Access Compliance Report Public Rights-of-Way (Curb Ramps)

Intersection ID: 42723 Main Street: STARGRASS_CT Cross Street: WAKEROBIN_LN Location: S

ADA ID: A37CB2666719 Ramp Type: Perp Initial Pass/Fail: Fail Overall Compliance: No Severity Score: 0

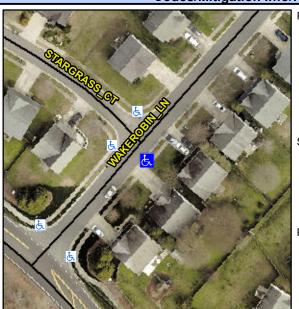
Field Measurements/Component Compliance					
Compliance Description		Data	Comp	Compliance Description	
N/A	Ramp Length (in)	49.0	Yes	Ramp Slope (%)	7.7
Yes	Ramp Width (in)	49.0	Yes	Ramp XSlope (%)	1.7
N/A	Flare Type LT	N/A	N/A	Flare Type RT	N/A
N/A	Flare Slope LT (%)	N/A	N/A	Flare Slope RT (%)	N/A
N/A	Flare Traversable LT?	N/A	N/A	Flare Traversable RT?	N/A
N/A	Landing Length (in)	N/A	N/A	DWS Provided?	N/A
N/A	Landing Width (in)	N/A	N/A	DWS Contrast?	N/A
N/A	Landing Slope (%)	N/A	N/A	DWS Length (in)	N/A
N/A	Landing X Slope (%)	N/A	N/A	DWS Full Width?	N/A
N/A	Landing Curb? (Y/N)	N/A	N/A	DWS Offset (in)	N/A
N/A	Shared Landing?	N/A			
N/A	Gutter Ponding?	N/A	N/A	Gutter Slope (%)	N/A
N/A	Gutter Lip Ht (in)	N/A	N/A	Gutter X Slope (%)	N/A
N/A	Painted X Walk1?	No	N/A	Painted X Walk2?	N/A
	X Walk 1 Direction	To NW		X Walk 2 Direction	N/A
N/A	X Walk 1 Width (in)	N/A	N/A	X Walk 2 Width (in)	N/A
	X Walk 1 Slope (%)	6.7		X Walk 2 Slope (%)	N/A

X Walk 1 X Slope (%)	2.4		X Walk 2 X Slope (%)	N/A
N/A	Ramp inside XWalk1?	N/A	N/A	Ramp inside XWalk2?	N/A
	Road Slope (%)	N/A	N/A	Clear Space?	N/A
	Road X Slope (%)	N/A	N/A	Clear Space to XWalk (in)	N/A
N/A	Any Obstructions?	N/A	N/A	Storm Grate/Utility Hazard?	N/A
	Obstruction Type		l	Storm Grate/Utility Type	
		N/A			N/A
			Yes	Surface Condition? (G/P)	Good

Remove & Replace Entire Ramp.
